HISTORIC AND DESIGN REVIEW COMMISSION

August 21, 2019

HDRC CASE NO: 2019-462
ADDRESS: 2330 W SUMMIT
LEGAL DESCRIPTION: NCB 9078 BLK LOT 2 AND W 20 FT OF 3
ZONING: R-6, H
CITY COUNCIL DIST.: 7
DISTRICT: Monticello Park Historic District
APPLICANT: Pete and Carol Kohrs
OWNER: Pete and Carol Kohrs/KOHRs PETER J & CAROL C
TYPE OF WORK: Xeriscaping and site work
APPLICATION RECEIVED: August 02, 2019
60-DAY REVIEW: October 01, 2019
CASE MANAGER: Huy Pham
REQUEST:

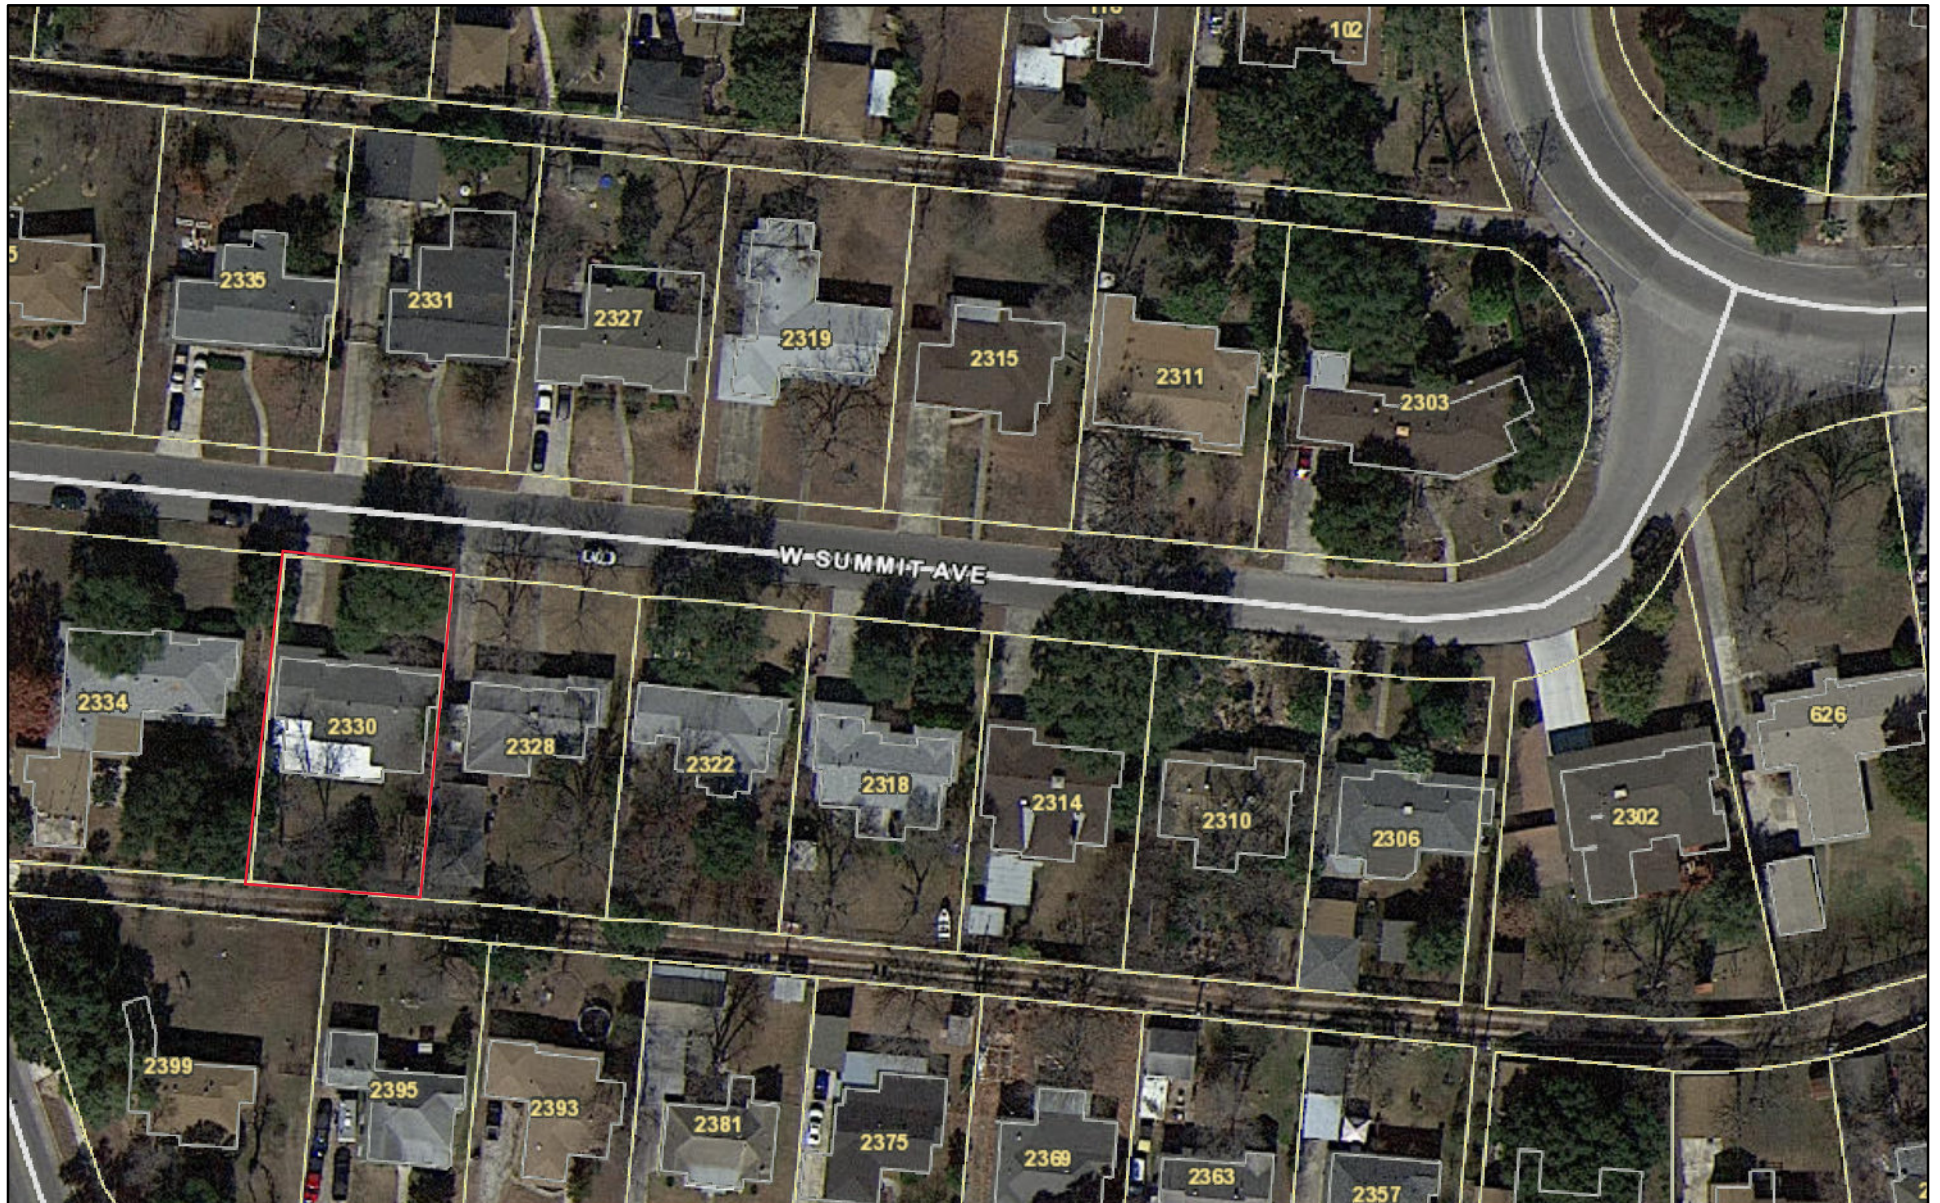
- d. LANDSCAPE – The applicant has proposed to remove a portion of the front yard abutting the right of way to feature shadow rock bed and xeric plants including Texas Lantana, Blue Plumbago, and Gregg's Mist flower among others as recommended by Bexar County Master Gardeners and The San Antonio Botanical Garden. Per the Guidelines for Site Elements 7.A.ii., ii. Historic Lawns—Do not fully remove and replace traditional lawn areas with impervious hardscape. Limit the removal of lawn areas to mulched planting beds or pervious hardscapes in locations where they would historically be found, such as along fences, walkways, or drives. Low-growing plantings should be used in historic lawn areas; invasive or large-scale species should be avoided. Historic lawn areas should never be reduced by more than 50%. Per the Guidelines for Site Elements 7.A.iii, Select native and/or xeric plants that thrive in local conditions and reduce watering usage; see UDC Appendix E: San Antonio Recommended Plant List—All Suited to Xeriscape Planting Methods, for a list of appropriate materials and planting methods; select plant materials with a similar character, growth habit, and light requirements as those being replaced. Staff finds that the effort to xeriscape is generally appropriate and similar front yard landscaping is found at 2306 and 2311 W Summit. However, staff finds that shadow rock beds are not found on the block and should be avoided for a more appropriate natural color material.

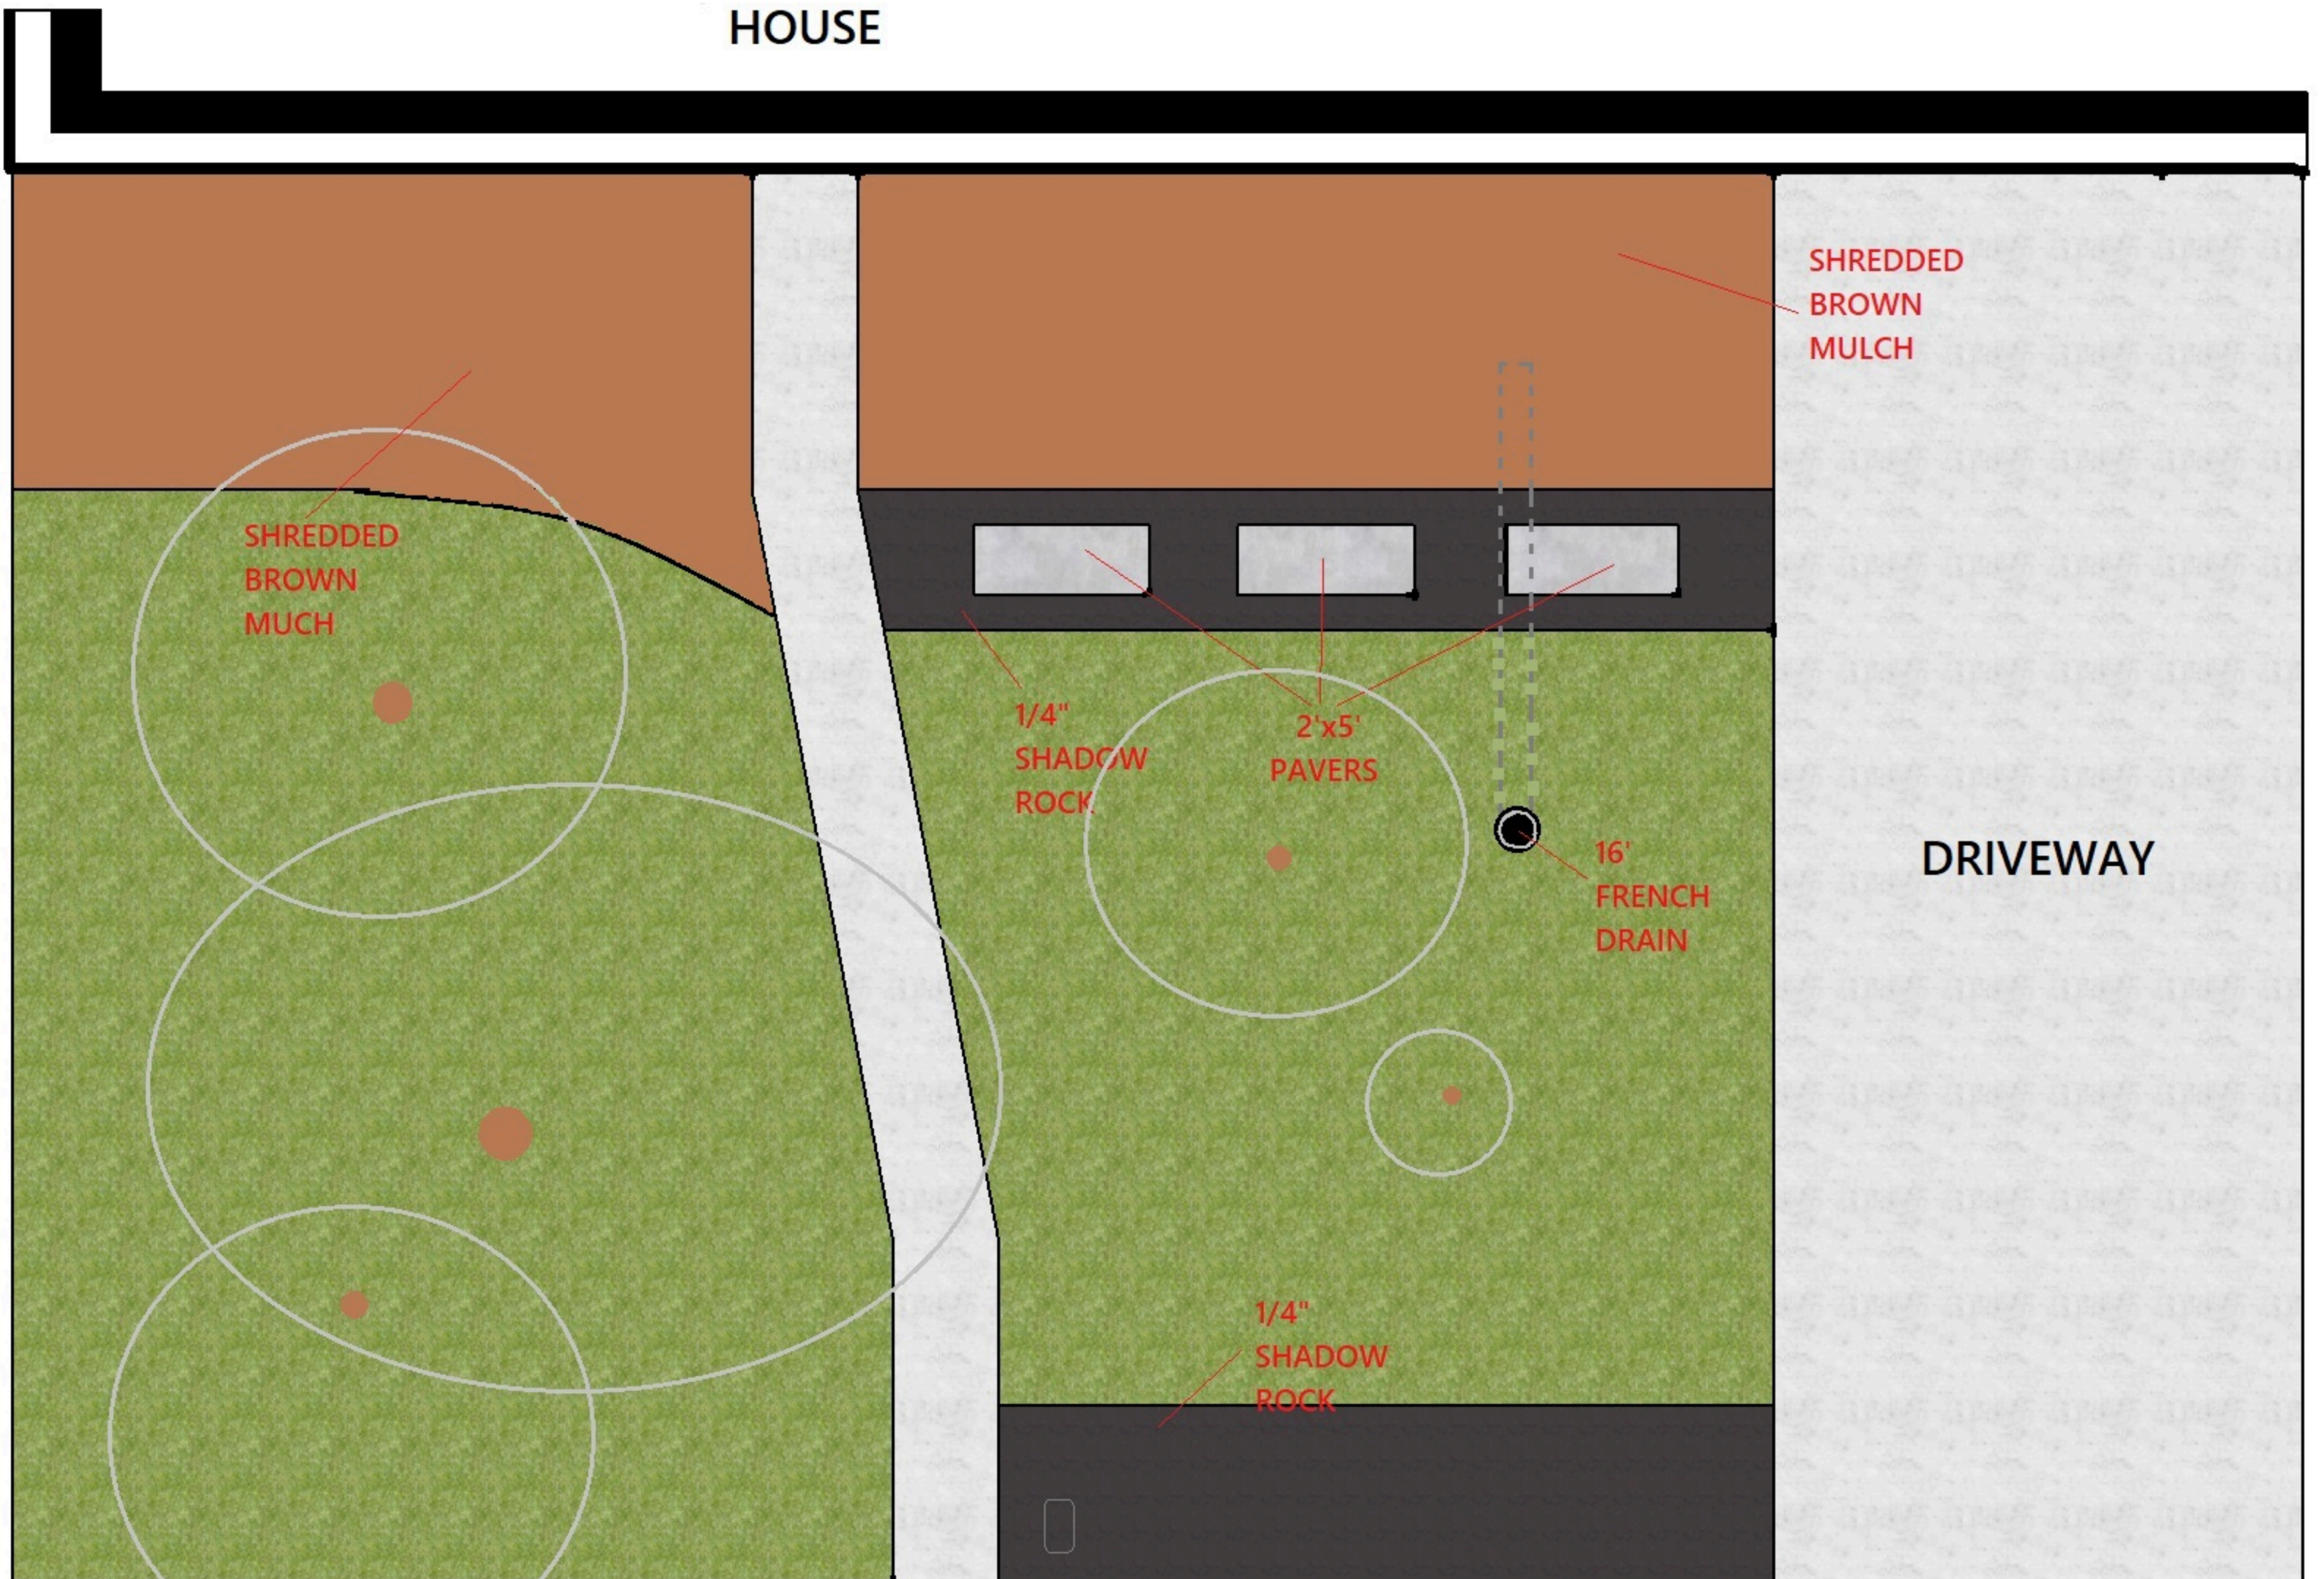
- c. WALKWAY – The applicant has proposed to replace a non-original stone walkway with a shadow rock path with three (3) 2' by 5' concrete pavers, from the driveway to the front door along the front façade of the structure. The existing stone walkway was installed circa 2014 and was generally appropriate to the style of the structure and context of the block. Per the Guidelines for Site Elements 5.A.ii., replace those portions of sidewalks or walkways that are deteriorated beyond repair; every effort should be made to match existing sidewalk color and material. Per the Guidelines for Site Elements 7.B.i., do not introduce large pavers, asphalt, or other impervious surfaces where they were not historically located. Staff finds the proposed replacement is inconsistent with the Guidelines. The applicant may receive administrative approval for an in-kind replacement of the non-original stone walkway or an appropriate design that excludes large concrete pavers and shadow rock.

Staff does not recommend approval of item 1) walkway replacement as proposed based on finding c. The walkway may be approved administrative if it matches the non-original but appropriate existing walkway or feature a design that is consistent with the Guidelines, primary by excluding shadow rock and concrete pavers.

- i. That shadow rock should be removed from the design for a more appropriate natural color material.
- ii. That the applicant select native and/or xeric plants that thrive in local conditions and reduce watering usage; see UDC Appendix E: San Antonio Recommended Plant List—All Suited to Xeriscape Planting Methods
